ADDENDUM NO. 1

Sedgwick County Project: 811-U-4148; Bridge on Ridge Road between 39th and 47th Streets South (B497)

TYPICAL SECTION

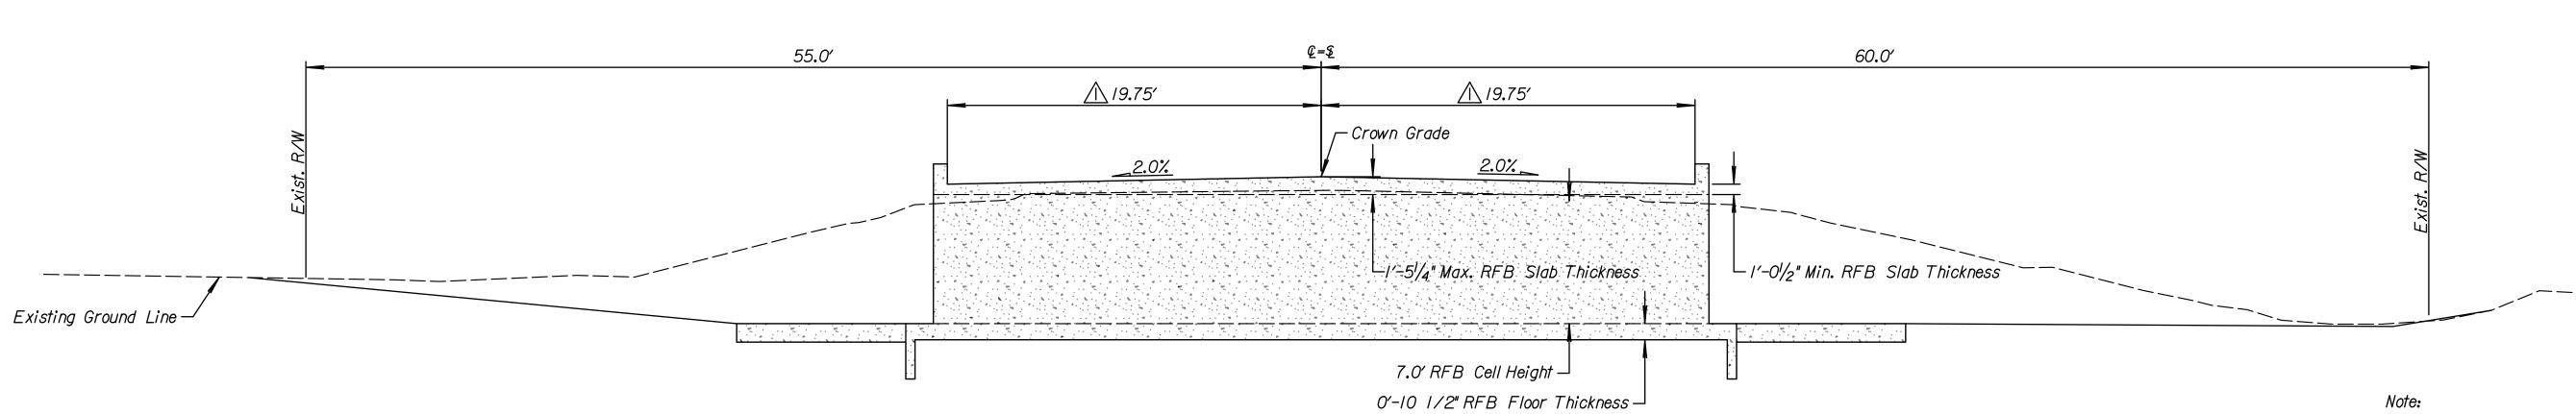
- Replace Sheet 2 with 2R (Width of RCB from hubguard to hubguard was updated.)
- Replace Sheet 3 with 3R (Updated/Added notes pertaining to bridge backwall protection and wearing surface grooving depending on method of construction selected.)
- Replace Sheet 14 with 14R (Added (MGS) to the end terminal description to help clarify correct type of end terminal.)
- Replace Sheet 18 with 18R (Added deck grooving dimension details and bid item, added 4" diameter weep hole dimensions and details, added armoring detail for edge of wearing surface, and updated bid items as necessary.)
- Replace Sheet 20 with 20R (Removed the bid item, "Bridge Backwall Protection".)

COUNTY	PROJECT NO.	YEAR SHEET NO. TOTAL SHEETS
	SEDGWICK	B497	202I 2R 43
60.0' ries Varies 6.0' 6.0' 2:/ 3:/ to 4:/	Exist R/W		REVISED PLANS
60.0°	R/W		
I'-0 ^l / ₂ " Min. RFB Slab Thickness	Exist. P		
	Note:		
	See Cross S	ections for Special D are typical. See Plan variations.	itch Elevations n and Cross Section
		nht-of-Way and Easen	nent Sheets for Existing
		Compaction is consid	dered <u>SUBSIDIARY.</u>
		<u>^</u> 202I-08-03	- Updated Dimension
	SEDG	WICK COUNTY	PUBLIC WORKS
		TYPICAL SE	ECTIONS
		SEDGWICK COUN	NTY, KS

GENERAL NOTES

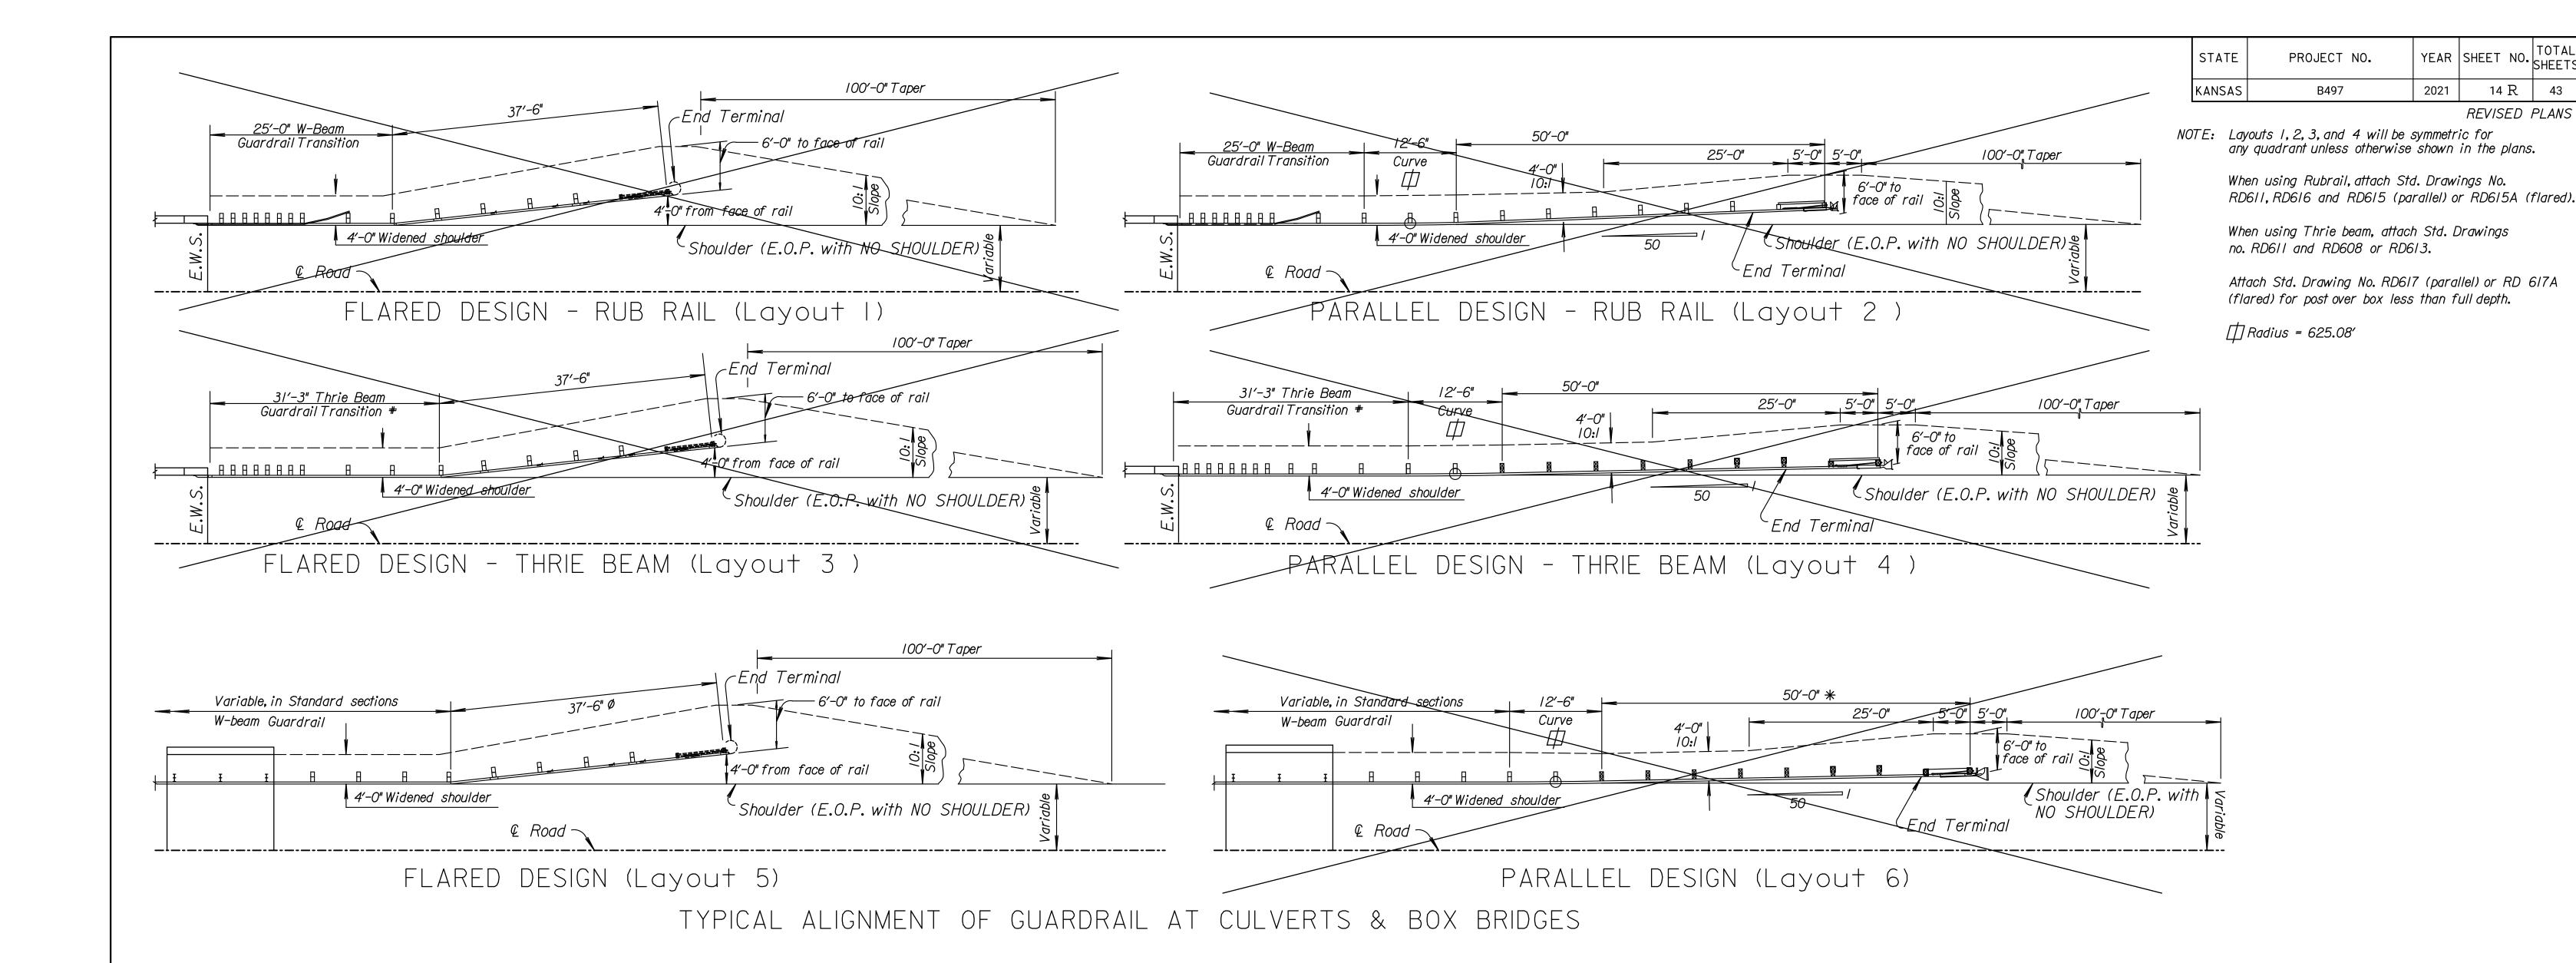
↑ 2021-08-03 - Updated Notes

\triangle The wearing surface for both the top of the RCB (if cast in place) and/or the wearing surface for the 6" reinforced distribution slab (if pre-cast) shall have a grooved surface. This work shall be paid for by the bid item, "Bridge Deck Grooving" by the S.Y.

GUARDRAIL INSTALLATIONS

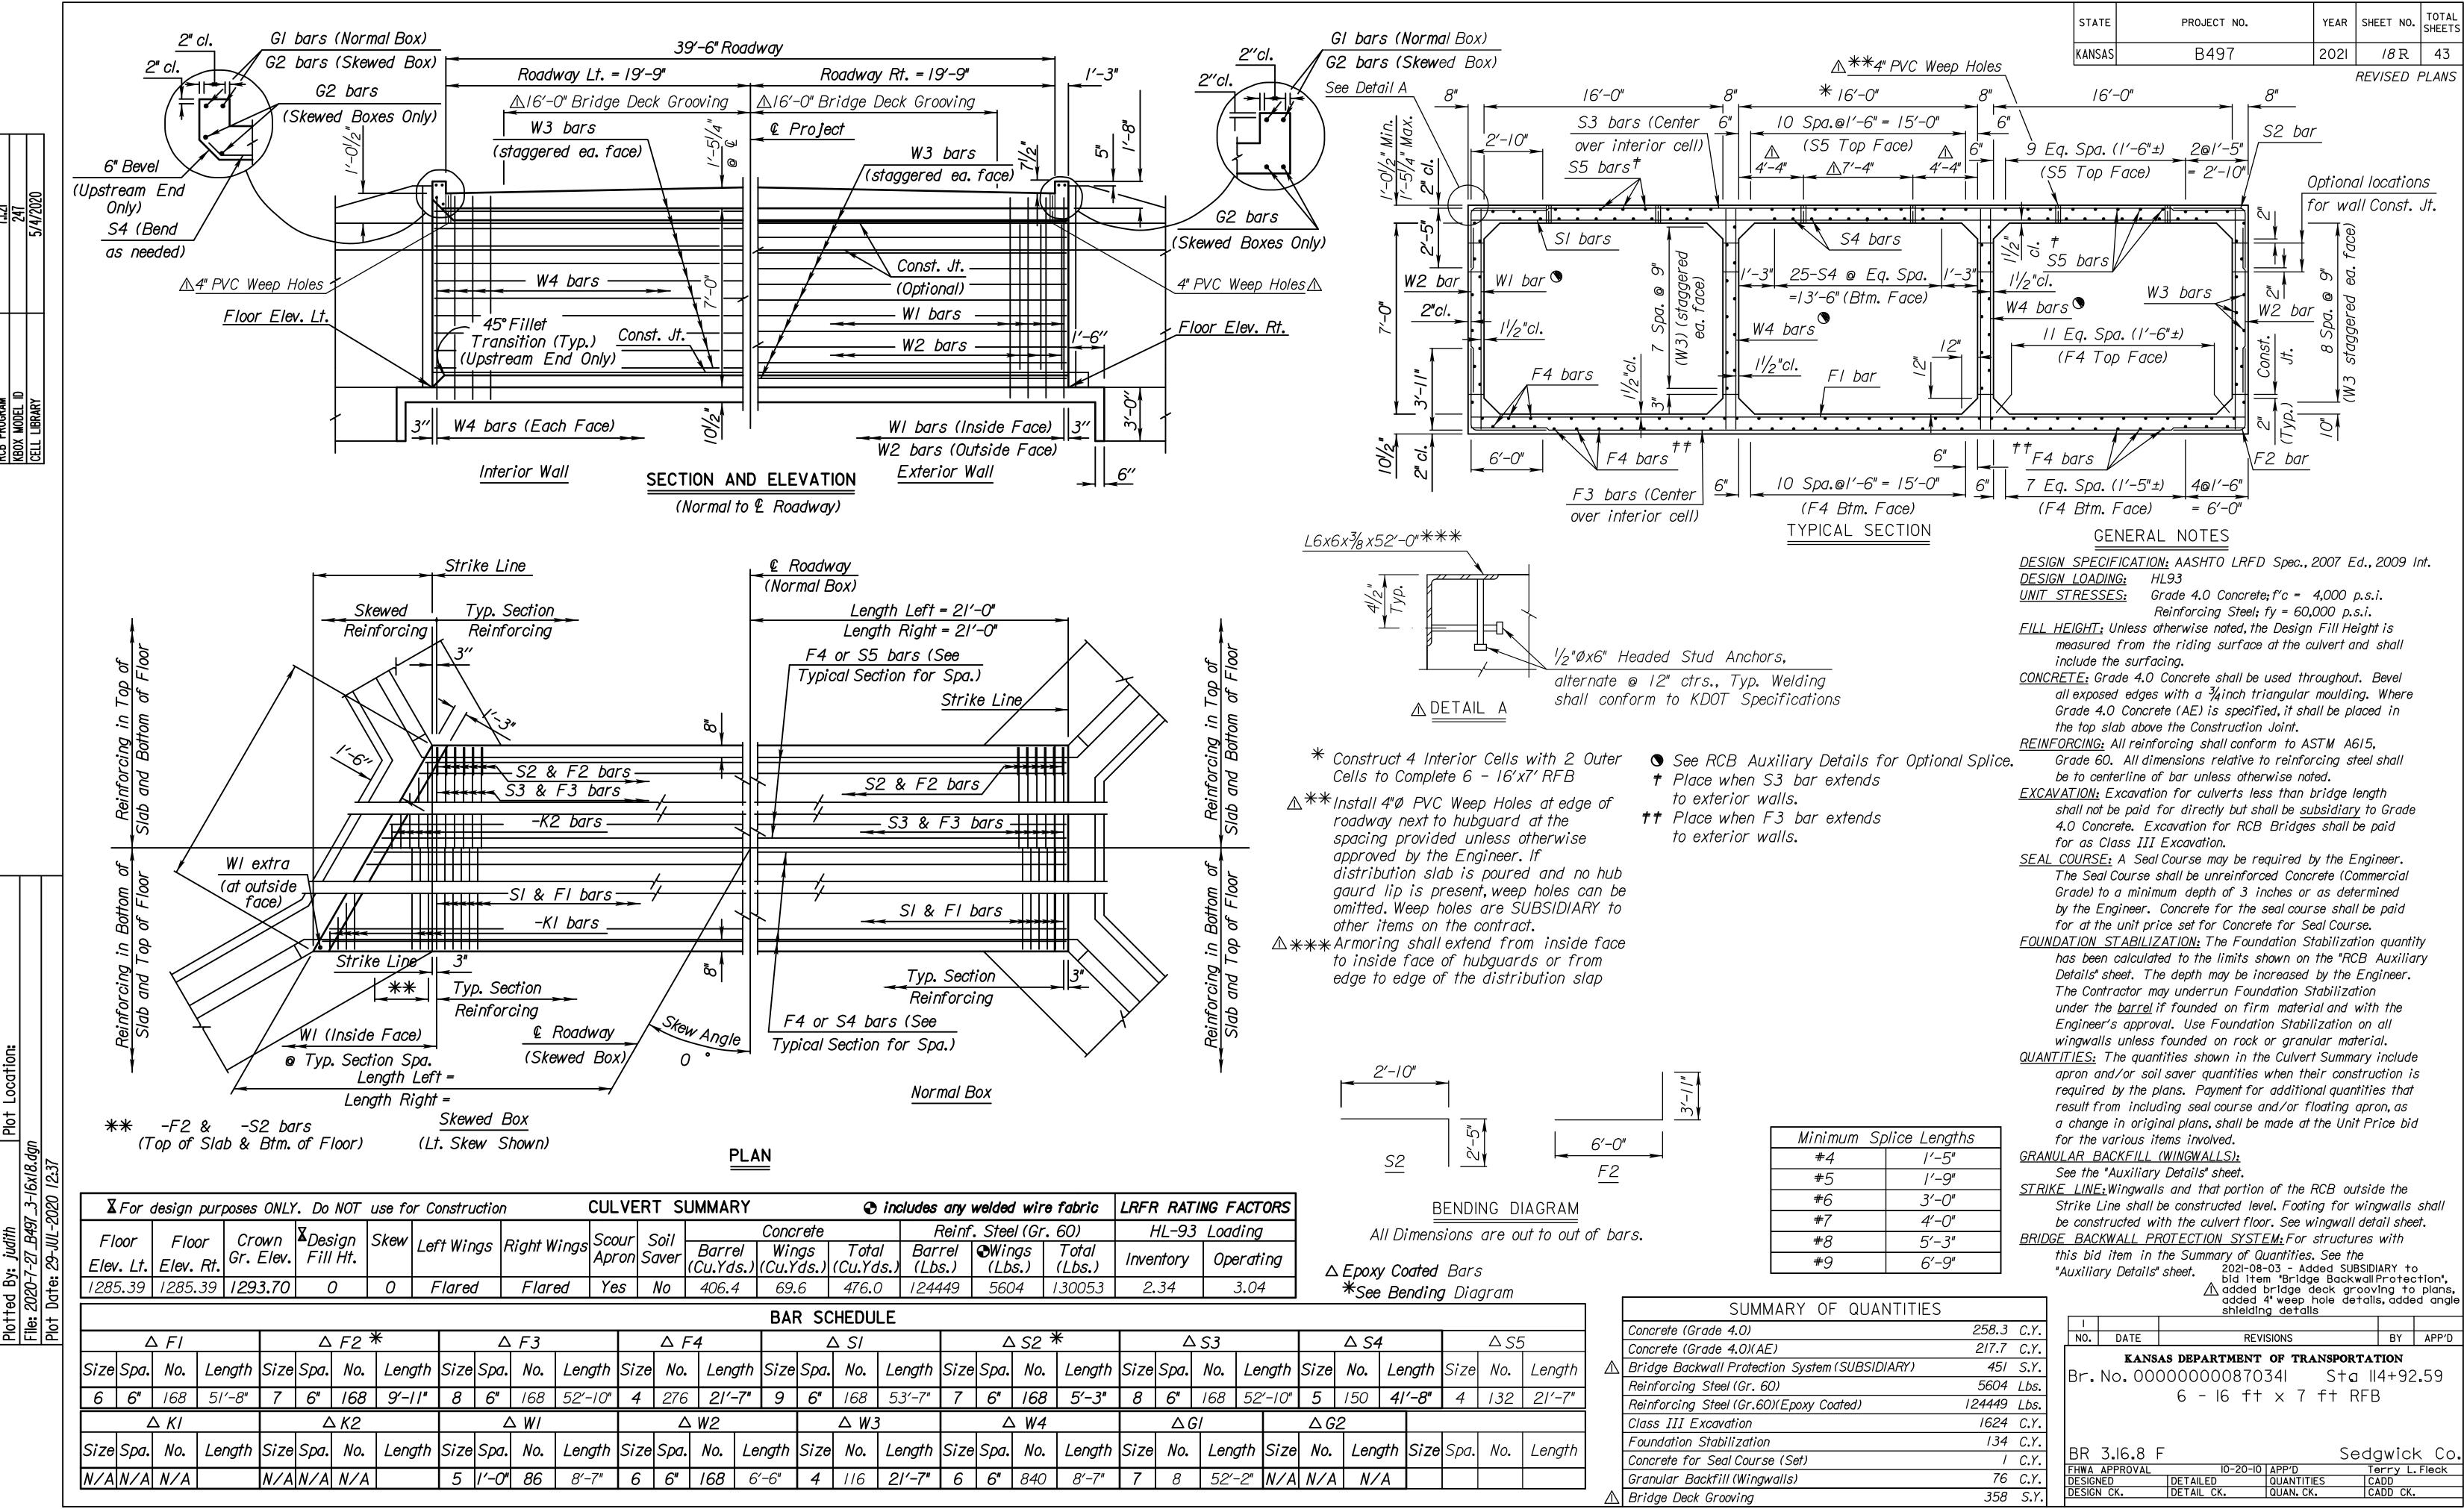
↑ 2021-08-03 - Added MGS to Guardrail End Terminal Description
